Design Review Summary Reports
DRL Item 4, DRD CM-024TC

Identifying
Incremental Section
Release Sheet

POWER SYSTEM
PRELIMINARY DESIGN
REVIEW MINUTES

INSTRUCTOR/OPERATOR
STATIONS

FIGURE 3.1-3 PANORAMIC VIEW OF THE MBIS CONSOLE

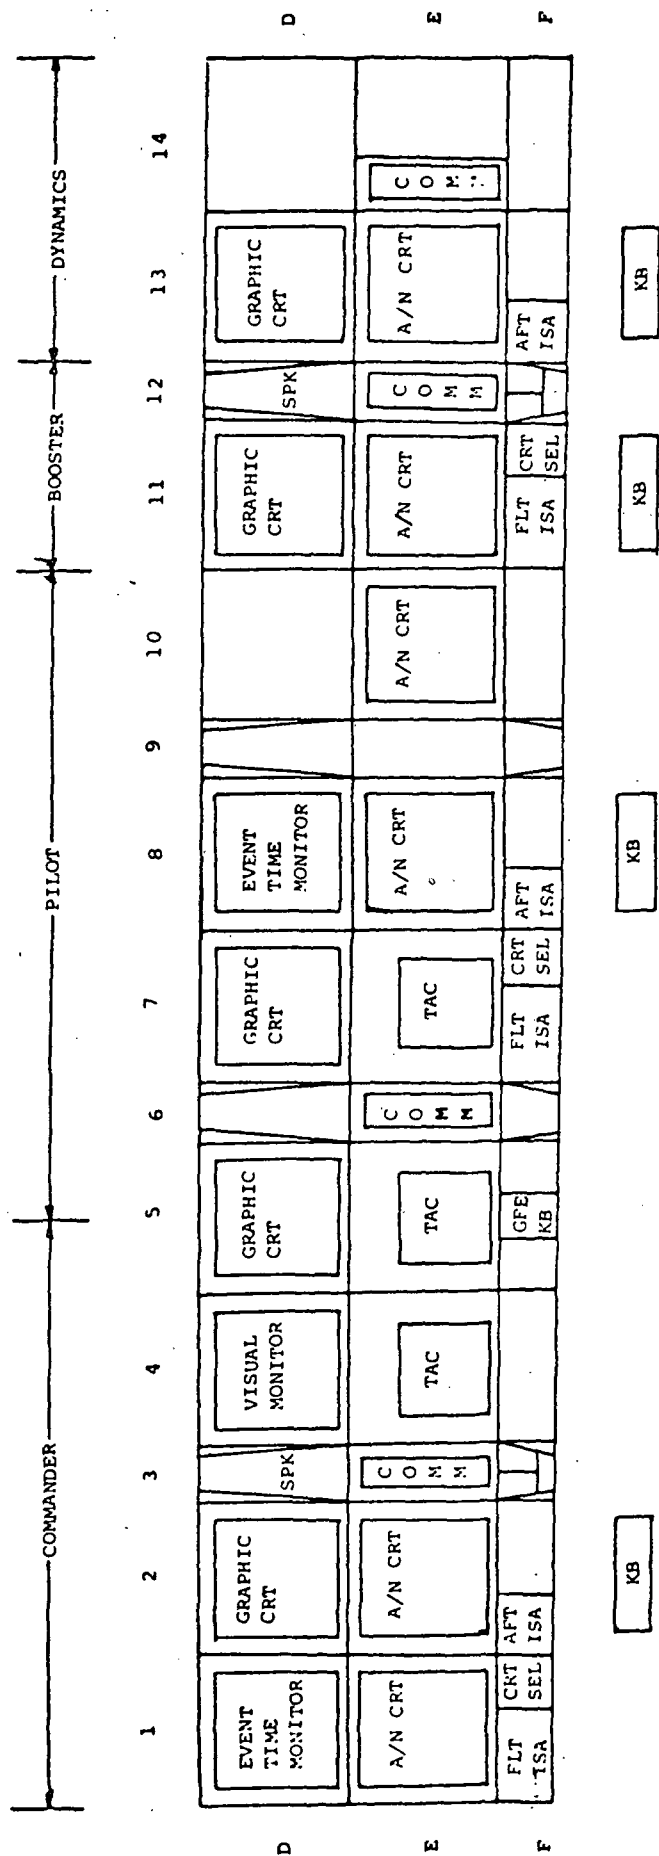
A revised IS panel layout and function list was presented (Attachment 1 and 1A). The revision was due to the fact that the TAC CRT's could not be mounted in 2 bays as originally anticipated.

SPD stated, in response to NASA questions, that the FBCS OBS will block the payload station and portions of the aft center panels in the FBCS. NASA wrote RID N22-02P (Attachment 4).

NASA questioned the requirement for a freeze repeater on panel 3C when the control is located adjointly on panel 4C. SPD responded that this was OAS design.

NASA questioned the visual system status on panel 4C - it does not reflect the DIG system.

HI-RESOLUTION
HARD COPY

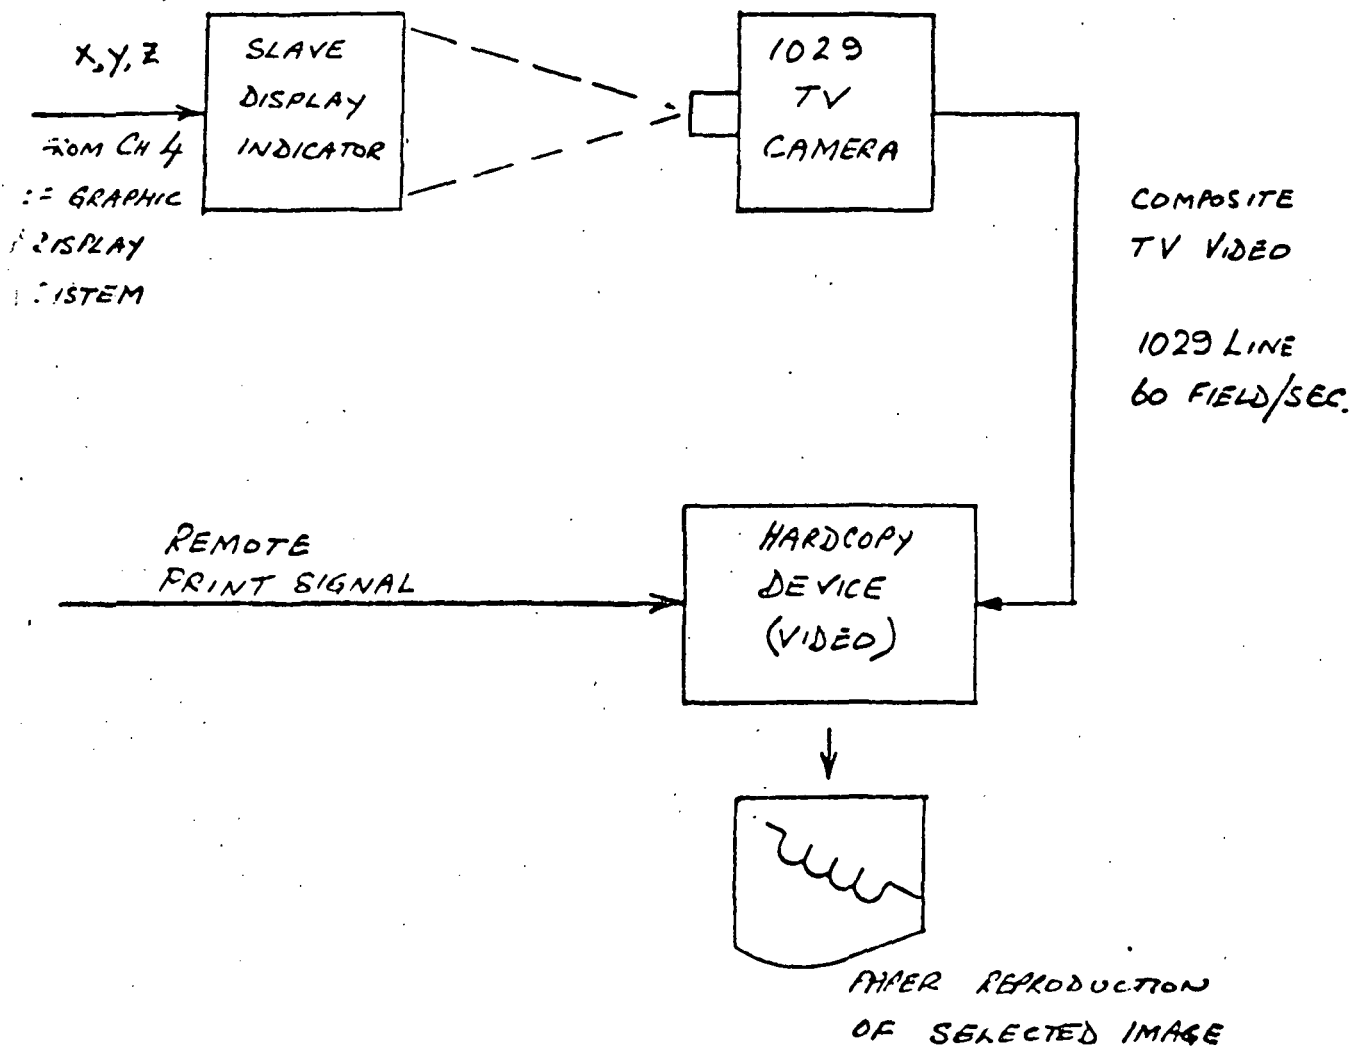
3. RECOMMENDATION:			
USE A HI-RESOLUTION HARD COPY WHICH ELIMATES THE NEED FOR TV MONITOR AND VIDEO RECORDER AND CHANGE TV CAMERA FROM A 525 LINE SYSTEM TO A 1029 LINE SYSTEM.

7. CONTRACTOR'S IMPACT STATEMENT:			
COST SAVINGS IF NEW APPROACH IS APPROVED.			
<i>W Brown</i> <i>4/22/76</i>			
8. SCD ACTION:			
<i>5R</i>			
APPROVAL			
SCD CHAIRMAN		DATE	
<i>McCafferty</i>		<i>4/22/76</i>

COLOR ALPHA-NUMERIC DISPLAY SYSTEM
COMPONENT DESCRIPTION

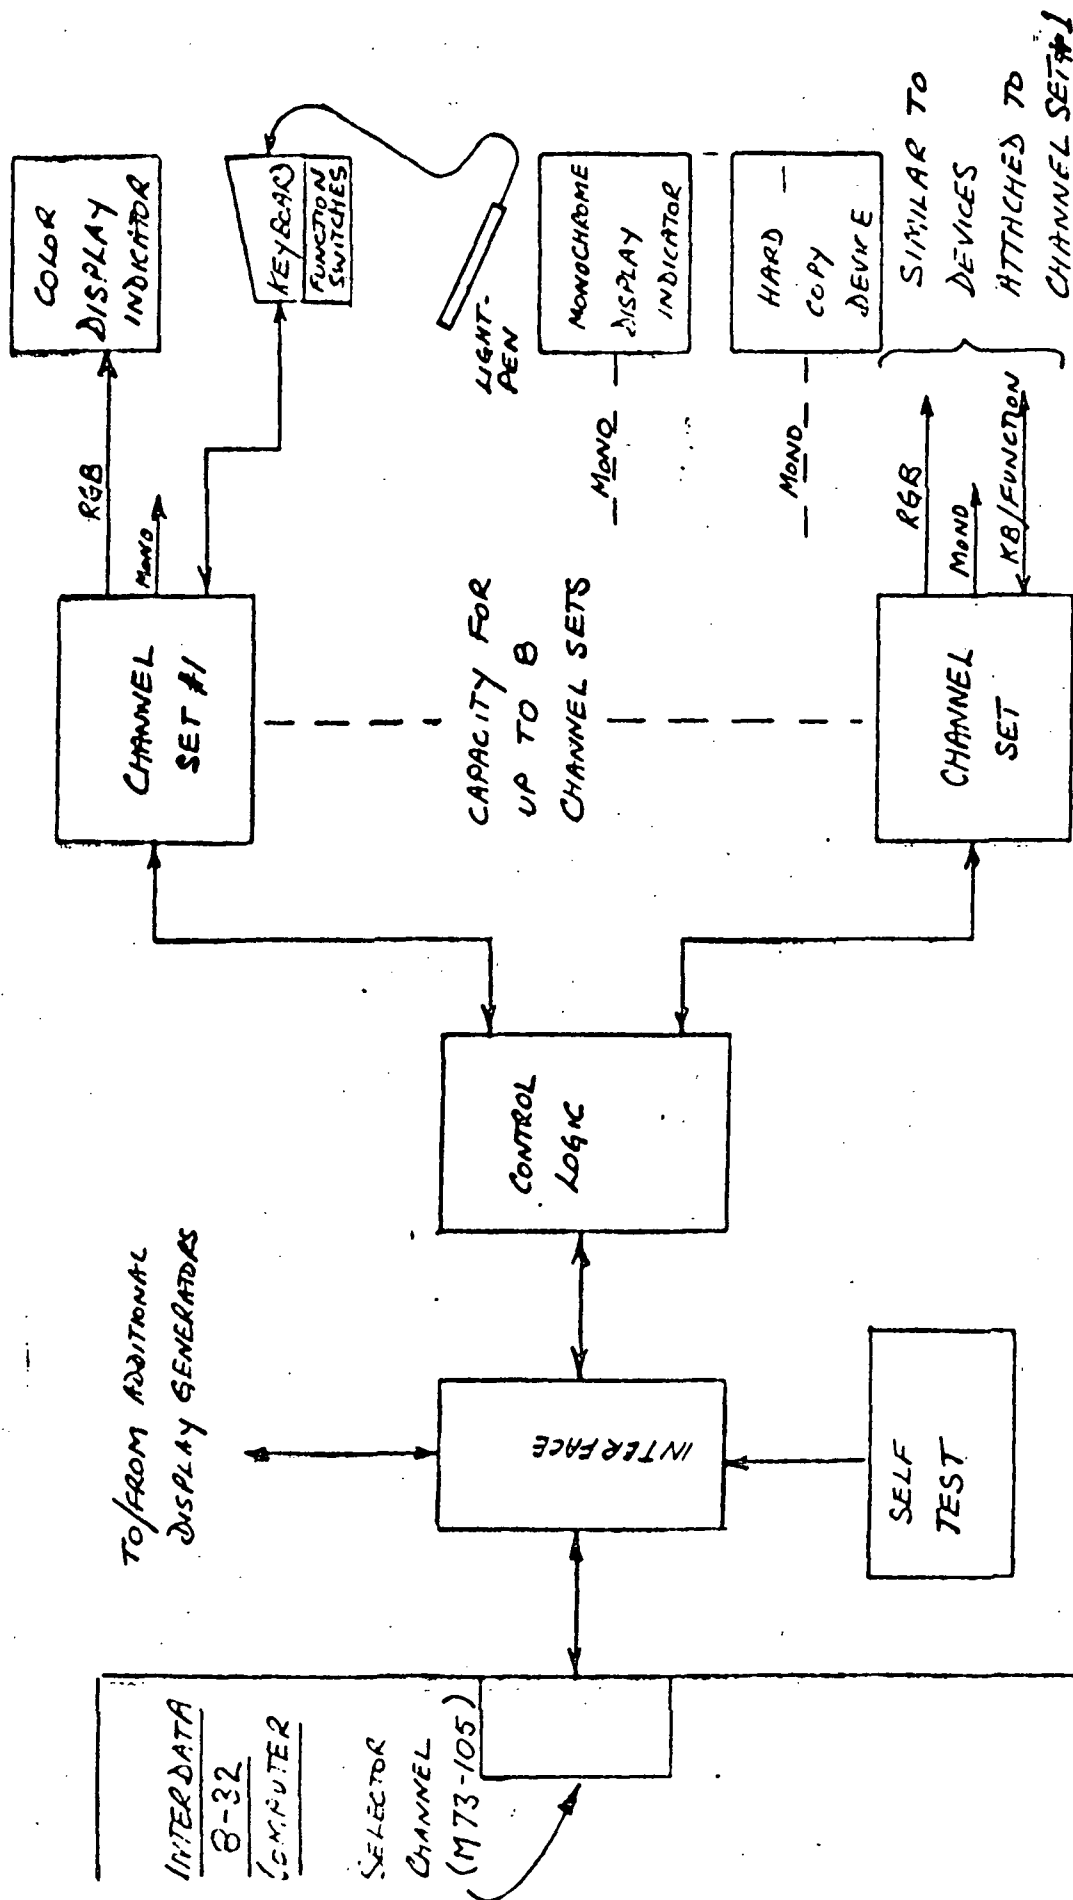
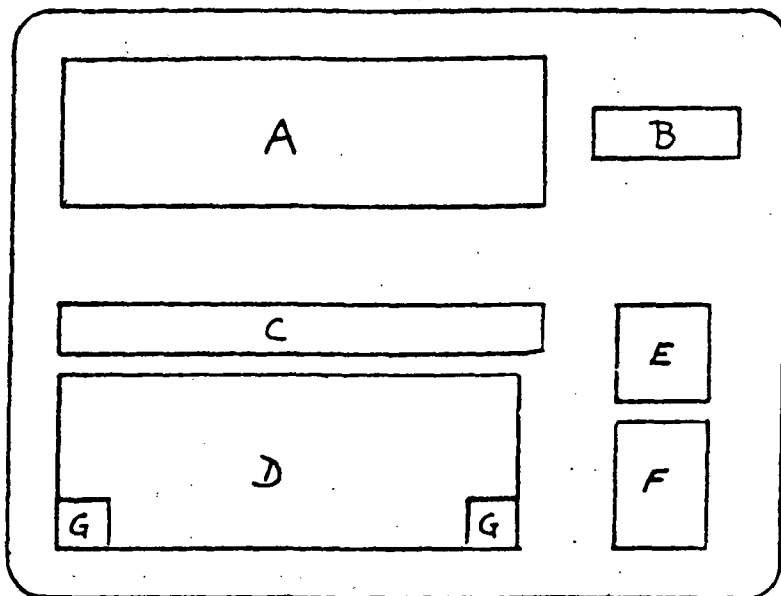
1. INITIATOR	ORGANIZATION	DATE	PROJECT
B. GIFFORD	JSC	4/21/76	N22-009P
TITLE			
IS/OS COLOR DISPLAY INDICATOR			
2. DESCRIPTION OF PROBLEM TWO TYPES OF RGB COLOR DISPLAY INDICATORS ARE AVAILABLE FOR INSTALLATION INTO THE IS OR OS CONSOLES (NOT ON-BOARD IS). THESE ARE THE CONRAC RHN/19 AND THE AYDIN 8020 DISPLAY INDICATORS. THE RHN 19 WAS A TRIAD TYPE OF SHOW MASK WHICH PROVIDES BETTER CHARACTERS RESOLUTION ON THE SCREEN BUT DOES REQUIRE CONVERGENCE ALIGNMENT MAINTENANCE. THE AYDIN 8020 HAS POOR CHARACTERS RESOLUTION BUT DOES NOT REQUIRE CONVERGENCE MAINTENANCE, DUE TO THE USE OF THE RCA PRECISION IN-LINE TUBE WHICH HAS SHORT VERTICAL SLITS RATHER THAN COLOR DOT TRIADS.

7. CONTRACTOR'S IMPACT STATEMENT:			
THERE ARE 21 COLOR MONITORS IN THE SMS CONFIGURATION. DISPLAY INDICATOR LIST PRICES. AYDIN 8020 \$1,750.00 CONRAC RHN 19 \$3,655.00 <i>Program plan currently includes Aydin display indicators @ 1,750/each.</i> <i>Brown - 4/22/76</i>
